SACRAMENTO CITY PLANNING COMMISSION
1231 "I" STREET, SUITE 200, SACRAMENTO, CA 95814

APPLICATION: Variance to reduce the required 10 foot courtyard to three feet for a fifth unit on 0.14 developed acres in the Multiple Family (R-3A) zone.

LOCATION: 2304 H Street
Council District 3

APPLC. NO. P92-066

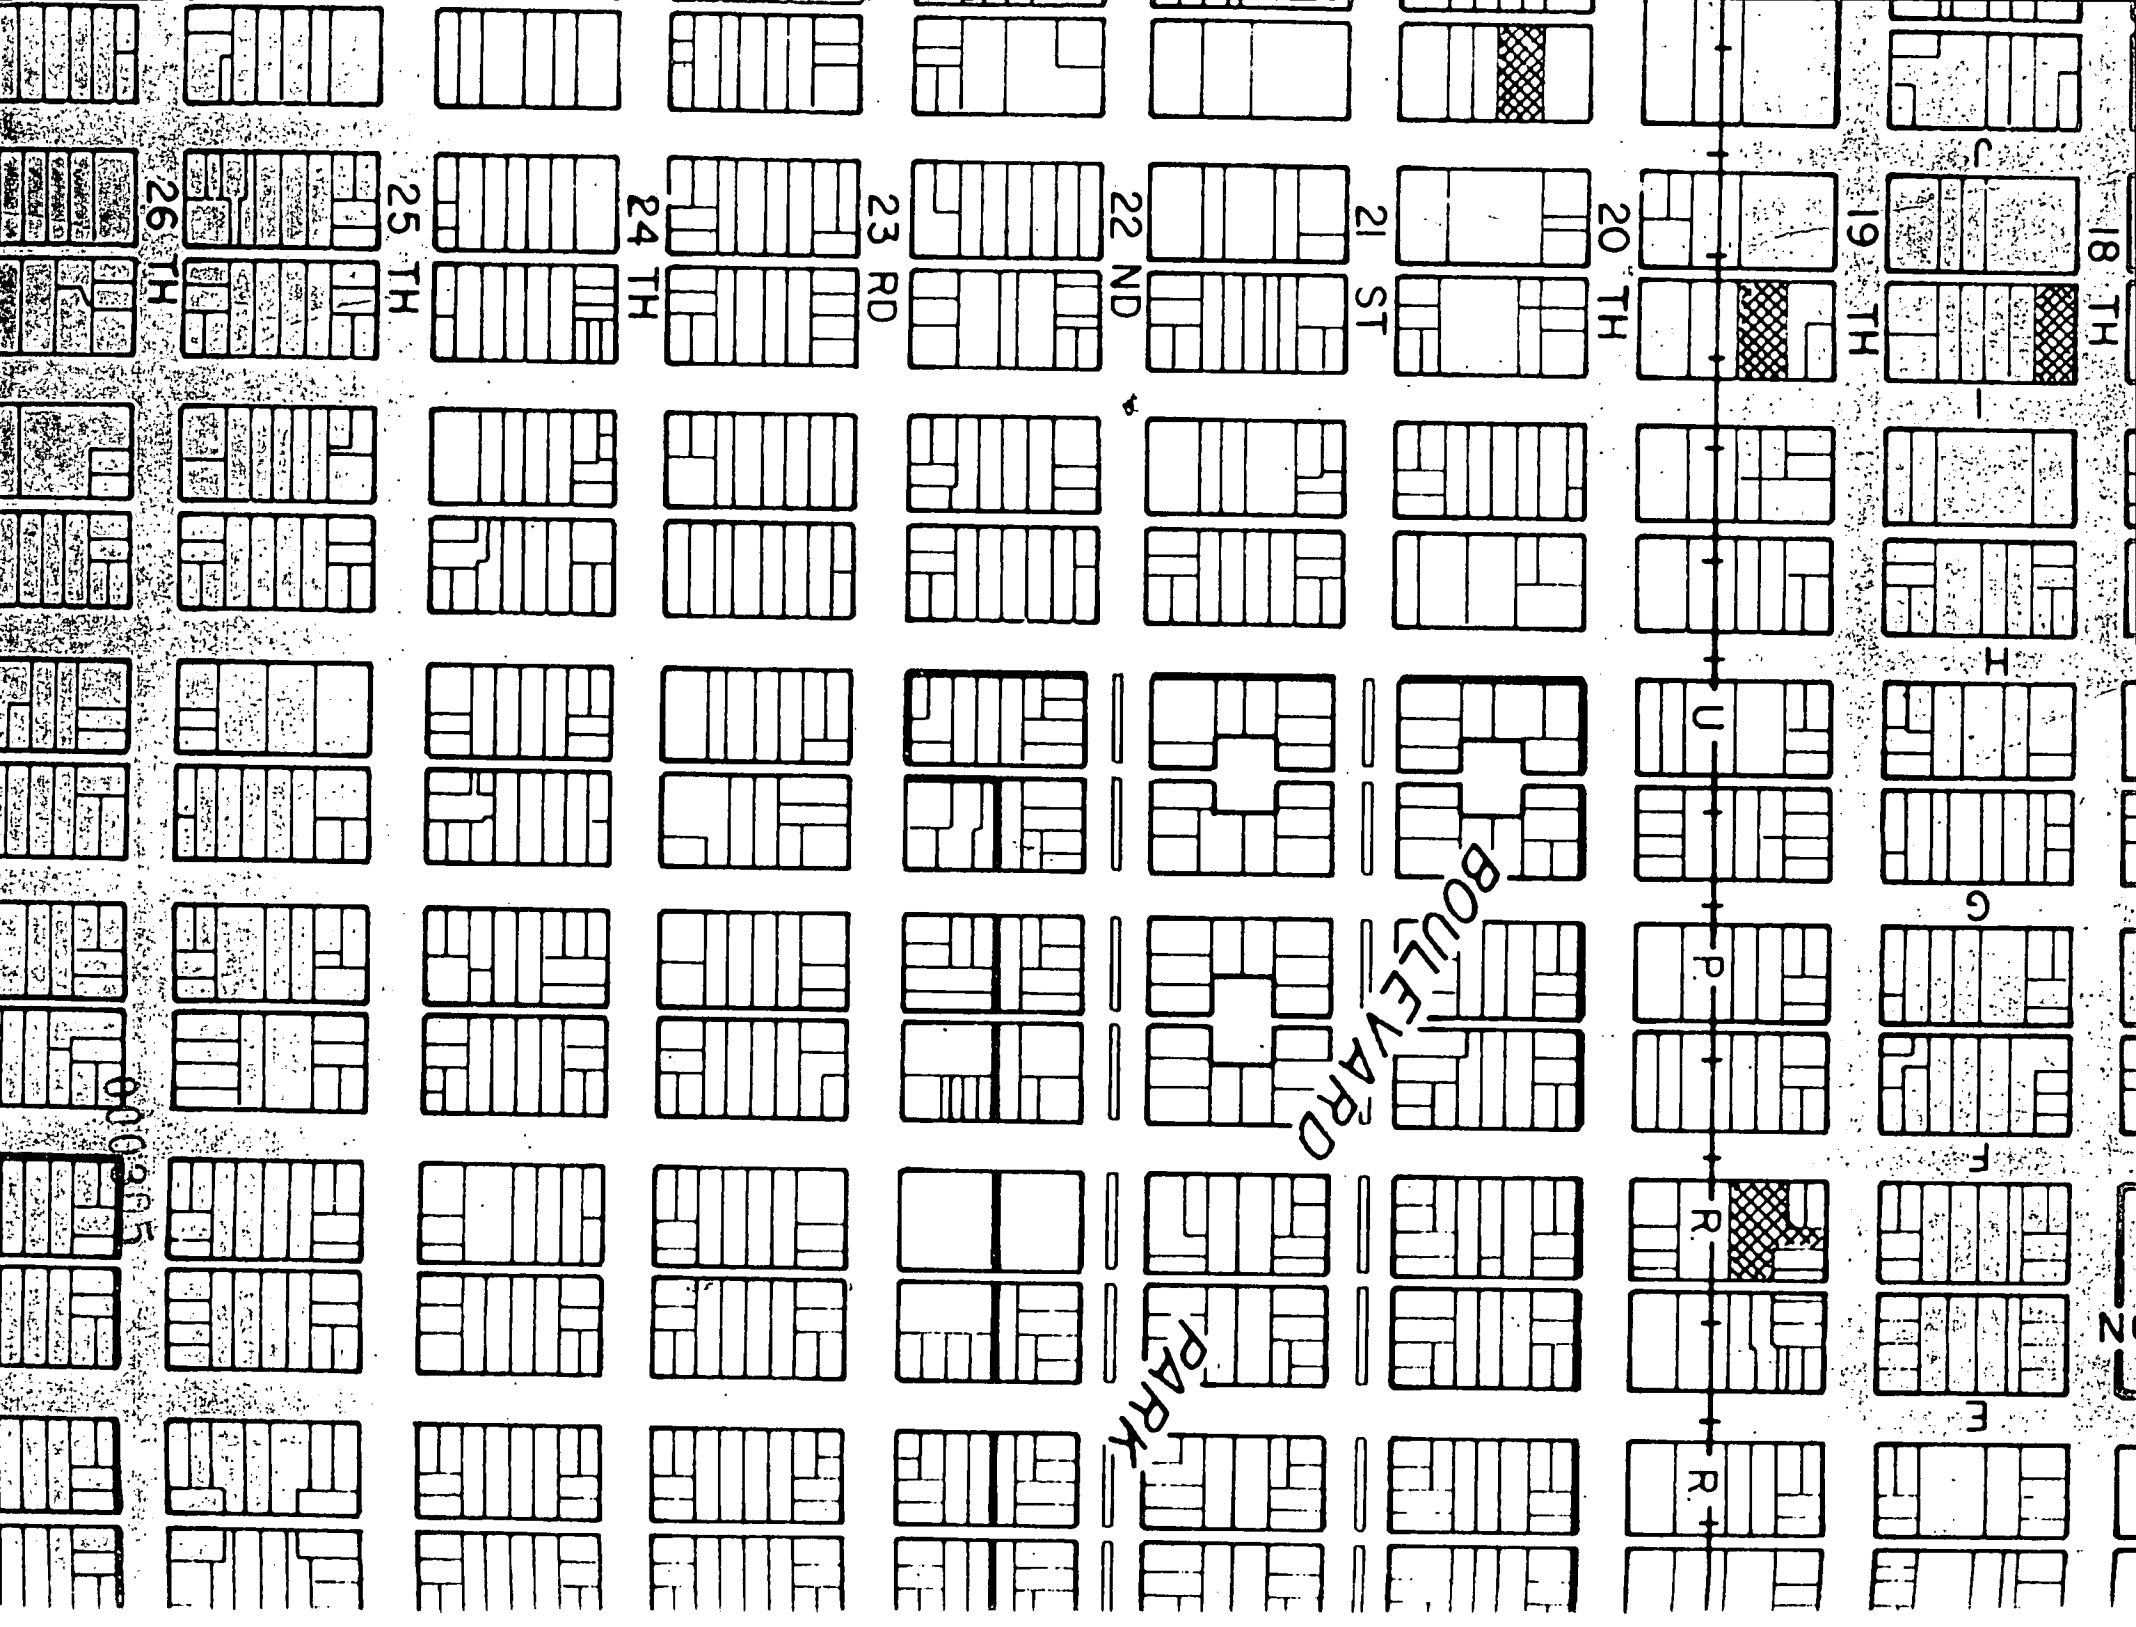
clearance on west parking adj.

clearance?, on east.

Trash enclosure?

SITE PLAN

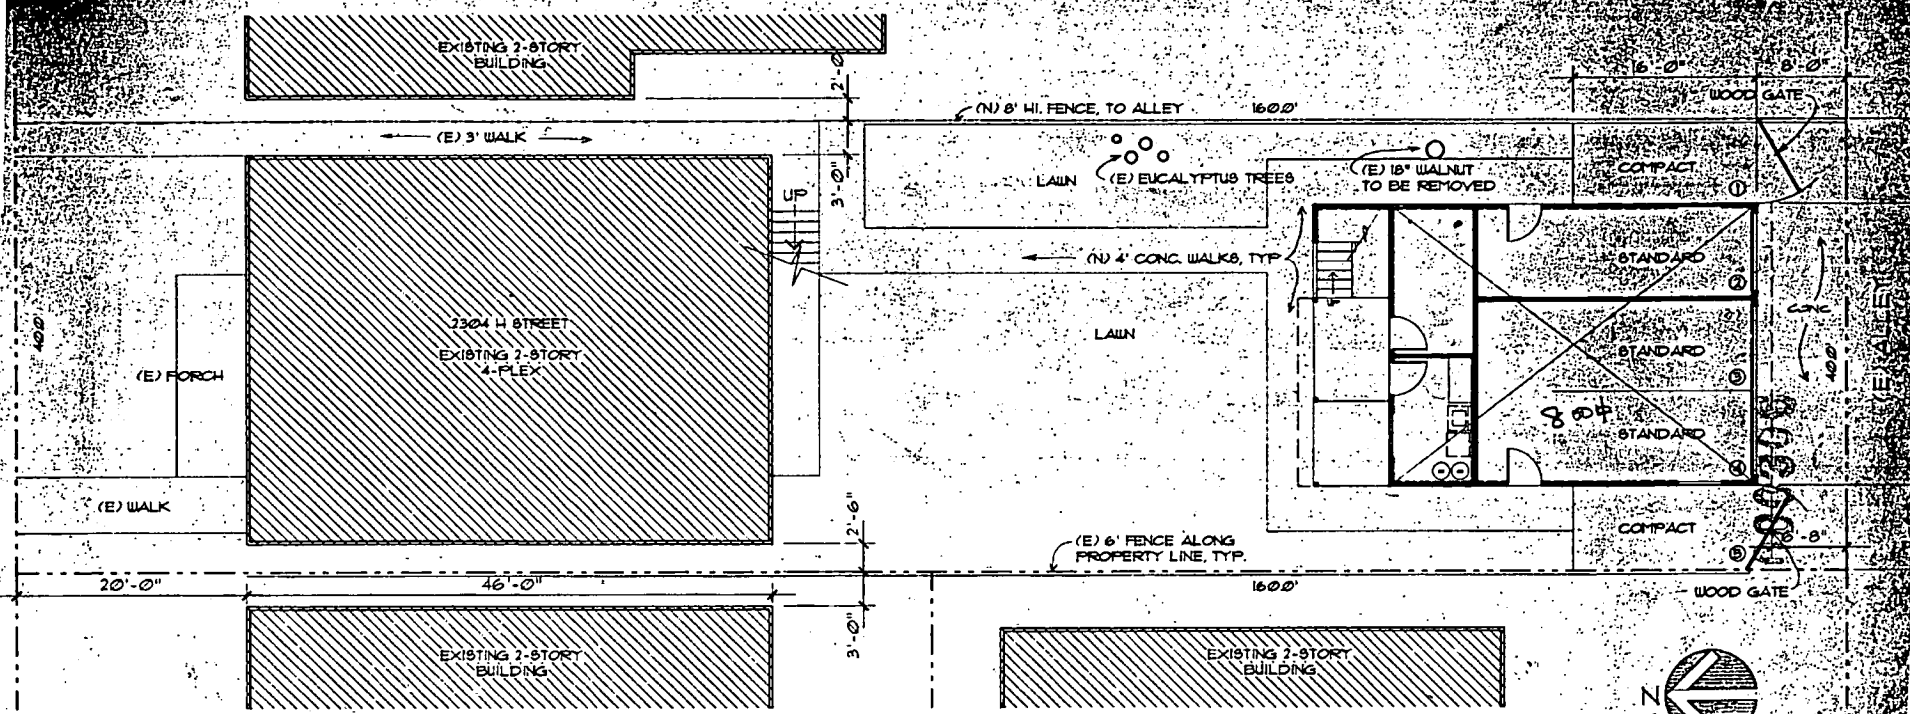
A three car garage with a unit above the garage is proposed at the rear of the site. Two compact spaces are proposed on either side of the garage with locking gates behind the spaces. The proposed parking plan provides the required on-site parking, four space for the existing four units and one space for the new unit. The proposed gates would not be allowed under the City Code since gates need to be recessed 20 feet from the property line when located across driveways or parking areas. Staff recommends the applicant relocate the gates to the front of the parking spaces which will allow security for the rear yard area. Currently, a six foot fence is locate on the east and west of the parking spaces. To the east is located the rear yard of a single family residence. To the west is located parking for the adjacent duplex. Staff has some concern regarding the visibility of these parking spaces. Staff would recommend a three foot high fence along the west property line the last 24 feet of the property to allow for visibility of the parking areas for both lots. However, the area along the east is unable to provide for visibility due to the rear yard of the single family. Staff, therefore recommends that this parking space be utilized for the recycling/trash enclosure.

Parking spaces along the east and west property lines have sight distance problems. Redesign to allow for visibility.

3. Along the south 24 feet of the west property line a fence no higher than three feet shall be constructed to allow for visibility.
4. The east parking space shall be designated for a recycling/trash enclosure shall be located in accordance with the Section 34 of the Zoning Ordinance.
